Reply to Ecology Comments for APP/22/00439 The South Downs College, College Road, Purbrook, Waterlooville, PO7 8AA

Our ref: 7707 Havant College

Date: 14/04/23

Appendix A – Habitat Enhancement Plan

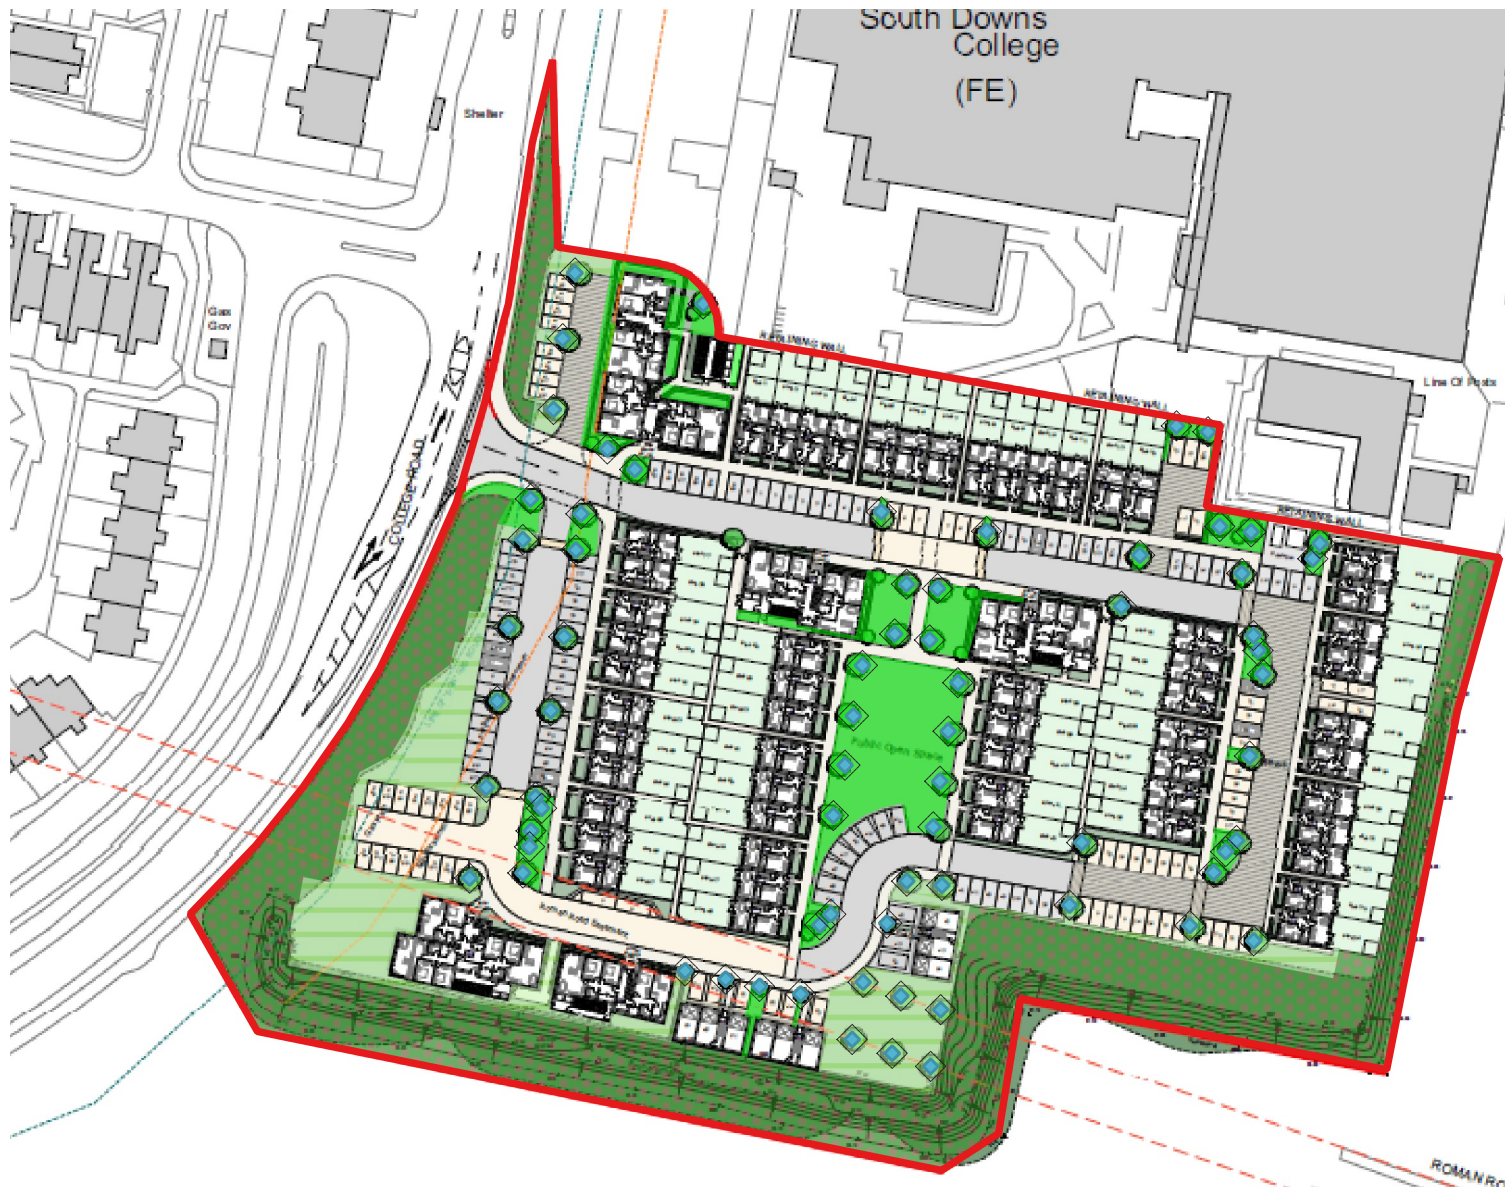
A biodiversity net gain assessment was completed for the site using Defra metric v.4.0 based on the latest proposals for the site, shown in **Appendix A**. This includes the measures set out above with the results of the metric resulting in a net gain in habitat units of 0.55, resulting in a 10.96% net gain. The metric has been provided alongside this technical note. Due to the loss of urban trees on the site the trading rules have not been met but it is not possible to plant enough trees within the site to offset this loss. The measures to provide wildflower areas, enhanced woodland and native planting are considered to provide beneficial gains considering the setting of the site and the importance of the woodland boundary.

The majority of the development is located on an area of hardstanding which has no ecological value. This will be replaced with areas of garden and residential dwellings alongside areas of wildflower. This will provide a more natural edge to sections of the retained woodland. It is not possible to provide additional woodland planting in the scheme due to the restrictions in planting in the west of the development zone relating to the presence of utilities. The retained woodland boundaries, 0.45 hectares, will be enhanced to compensate for the loss of 0.12ha of woodland habitat. These are currently considered to be in a poor condition and will be enhanced to a moderate condition.

The scheme includes the provision of 70 small native trees which will provide canopy cover and provide additional foraging resources for the local bat and bird populations. Areas of wildflower planting (0.15 hectares) will be created around the edges of the development which do not form part of the public open space.
